EAST ROSWELL LIBRARY
ADDENDUM NO. 05.1-2
APRIL 22, 2013

This Addendum No. 05.1-2 dated April 22, 2013 issued by Ajax Building Corporation of Georgia is hereby made part of Bid Package 05.1 – STRUCTURAL & MISCELLANEOUS METALS for the East Roswell Library. The changes and/or clarifications included in this Addendum shall be considered as part of the Bidding Documents and shall supersede, amend, add to, or subtract from those conditions included in the original Bidding Documents, including the Project Bid Package, Drawings, Specifications, previous Addenda, etc. This Addendum must be acknowledged in the space provided on the Proposal Form (included in Section II of the Bid Package). Failure to acknowledge this Addendum may subject Bidder to disqualification.

East Roswell Library

ADDENDUM NUMBER ONE

UTILITY PLAN

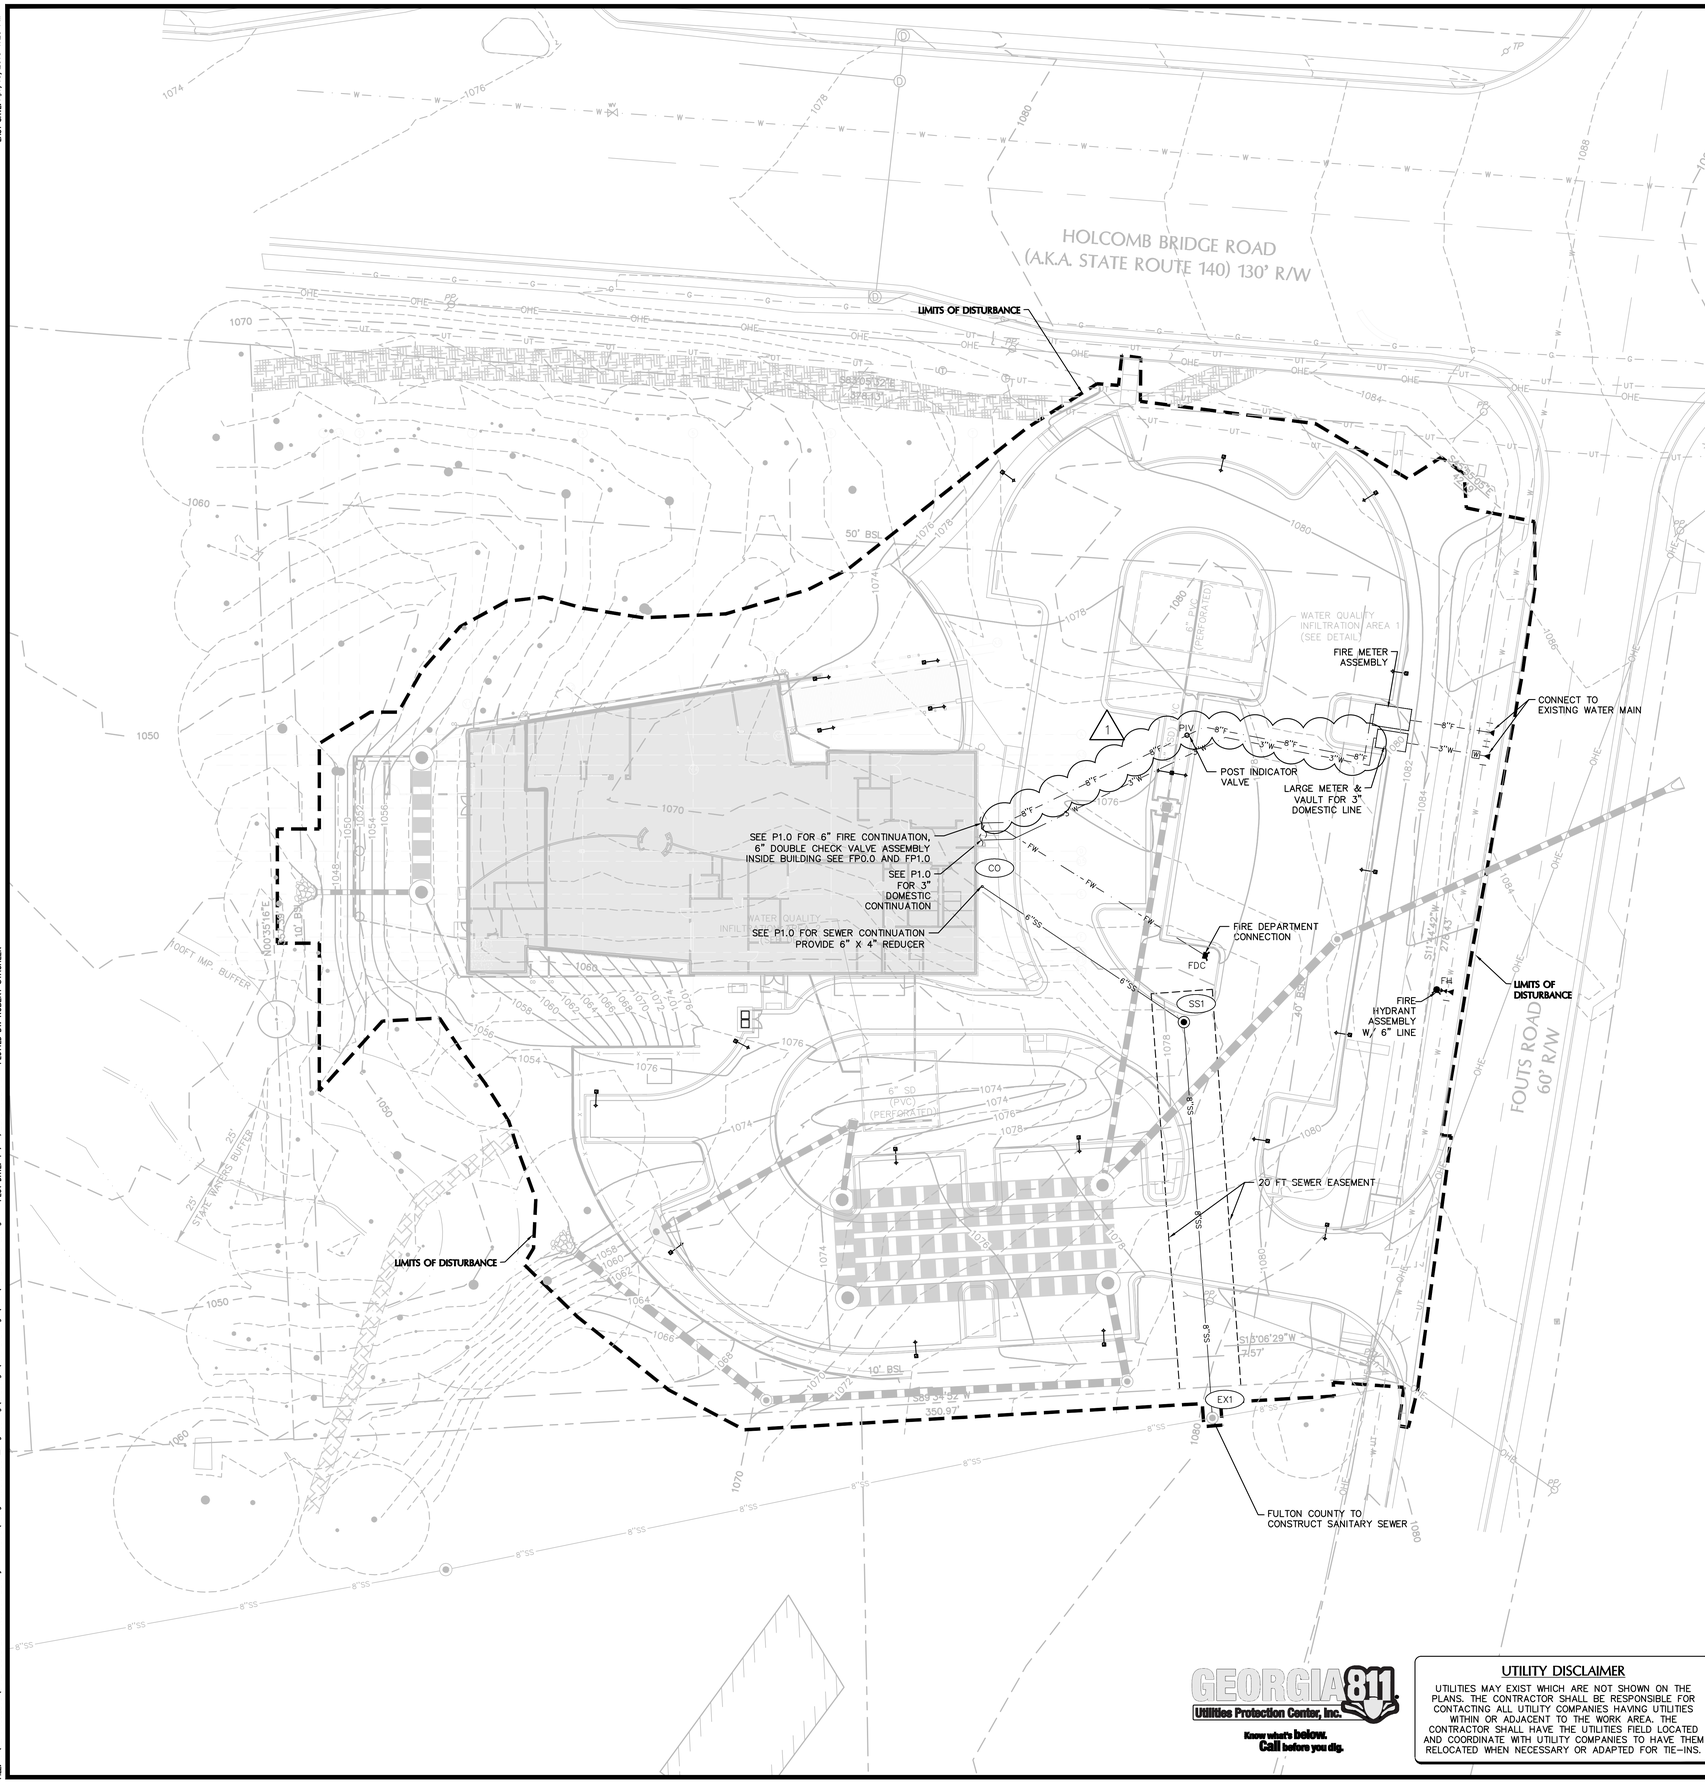
1. The following sheets are issued herewith:
   a. C-500 Utility: delete the sheet and replace with the attached sheet. The fire line between the fire meter assembly and the building has been upsized from a 6-inch line to an 8-inch line.
   b. FP0-0 - Fire Protection Legend, Schedule and Details: delete the sheet and replace with the attached sheet. Detail 4 – Added a 6" tag to the outgoing line on the Double Check Valve Assemblies Detail, DCVA, and changed the incoming fire line size from 6" to 8" on the same detail.

1 BASEMENT FLOOR PLAN - FIRE PROTECTION
1/8" = 1'-0"

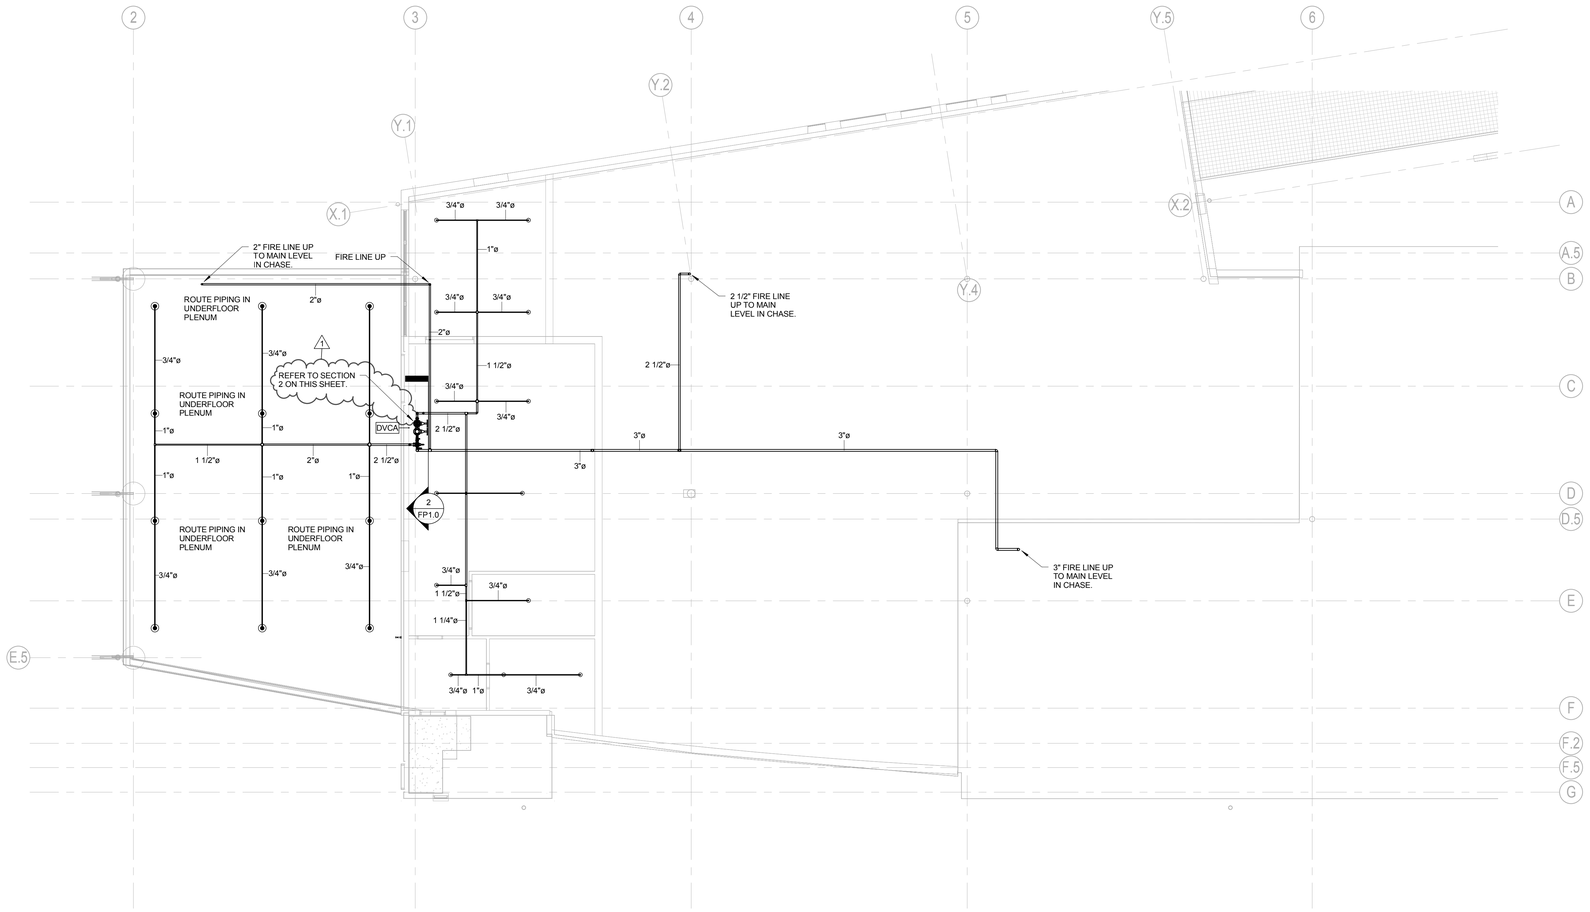
c. FP1-0 - Basement Floor Plan - Fire Protection: delete the sheet and replace with the attached sheet. Plan - Changed the note pointing to the DCVA to read as follows: "Refer to Section 2 This Sheet."
